## Service Bulletin

**Bulletin No:** JC-019-12

**Product Type:** STEINER 440

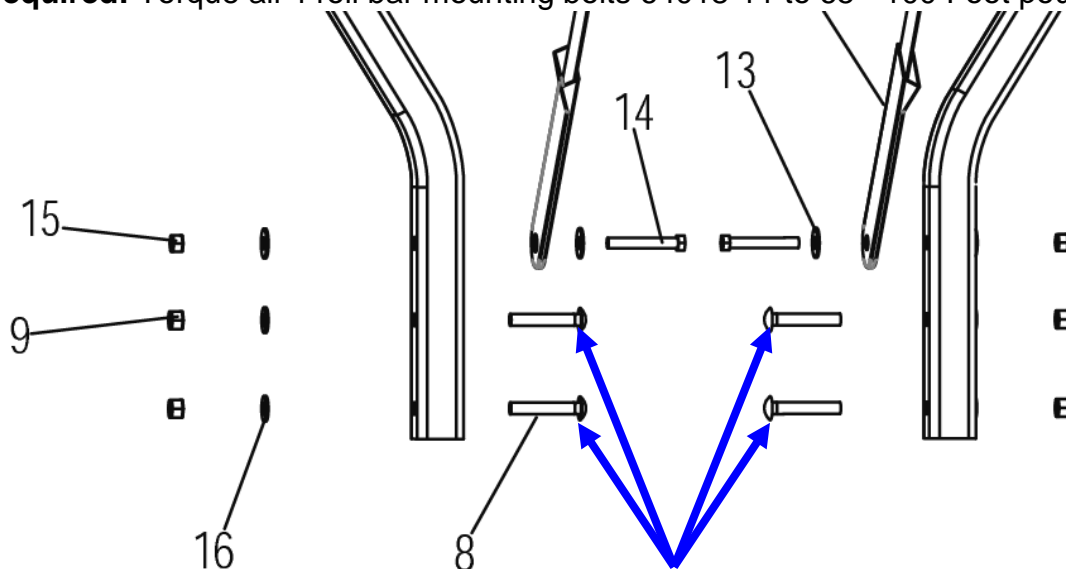
**Customer Issue:** Roll-over Protective Structure (ROPS) can move back and forth on the frame.

**Cause:** The 4 mounting bolts to the frame are not tightened properly in assembly.

**Action required:** Torque all 4 roll bar mounting bolts 64018-11 to 65 - 100 Foot pounds
